UNITED STATES PATENT AND TRADEMARK OFFICE

APPLICATION NO.	FILING DATE	FIRST NAMED INVENTOR	ATTORNEY DOCKET NO.	CONFIRMATION NO.
10/760,253	01/21/2004	Kia Silverbrook	MPA15US	1566
24011 7590 08/15/2007 SILVERBROOK RESEARCH PTY LTD 393 DARLING STREET BALMAIN, 2041 AUSTRALIA			EXAMINER MARTIN, LAURA E	
			ART UNIT 2853	PAPER NUMBER
			MAIL DATE 08/15/2007	DELIVERY MODE PAPER

Office Action Summary

DETAILED ACTION

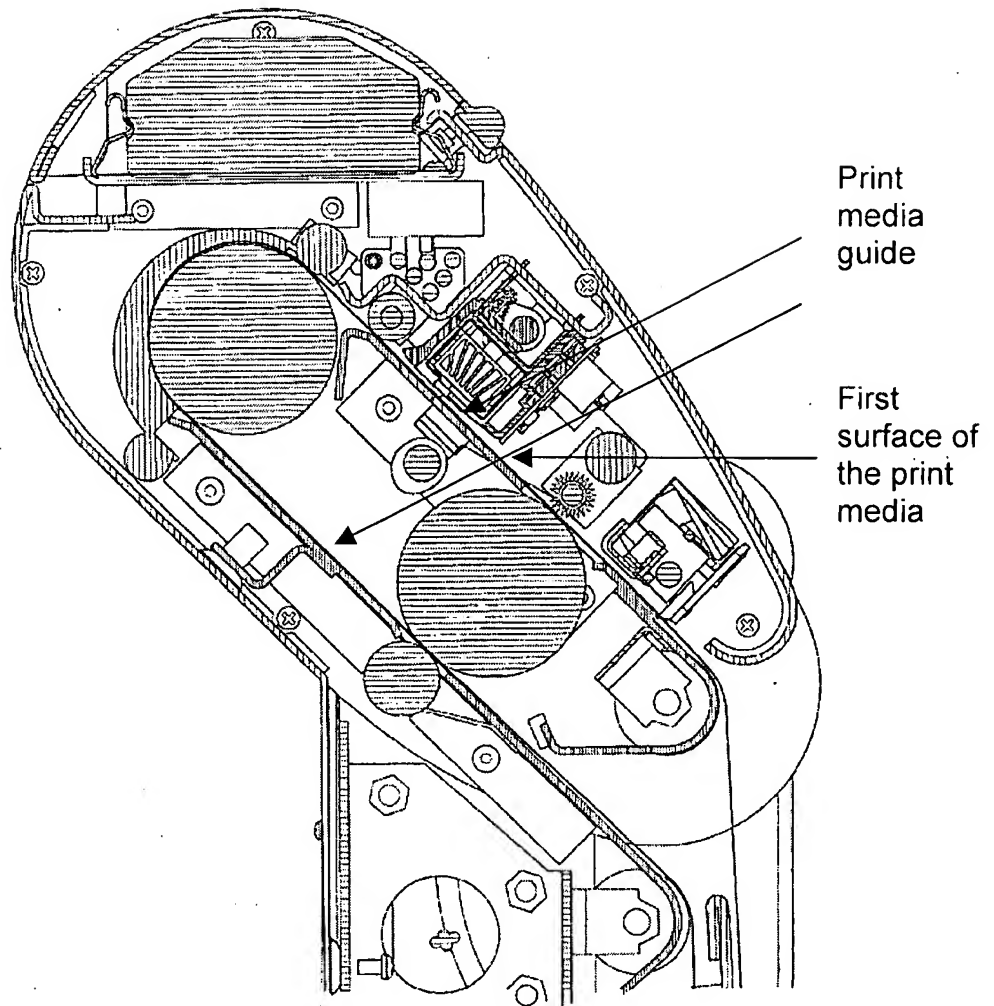
Silverbrook teaches a print media guide mounted to a slanted portion of the casing, adjacent the print surface, a slanted print media contact surface of the print media guide arranged to contact and guide the first surface of the print media over the print surface for printing onto the first surface (shown below).

Applicant's arguments filed 7/10/07 have been fully considered but they are not persuasive. Either side of the media could be the first surface; it is not clearly defined which surface is the first surface. As shown in figure 7, there is no contact between the paper and the nozzles (there is a small space between). Silverbrook (908) discloses a nozzle shield protecting the nozzles in column 3, lines 5-10. The paper would be guided or led over top of the nozzles, as the media would not be able to be guided into the nozzles. As shown in figure 7, the paper is guided between the printhead structure and a separate media guide.
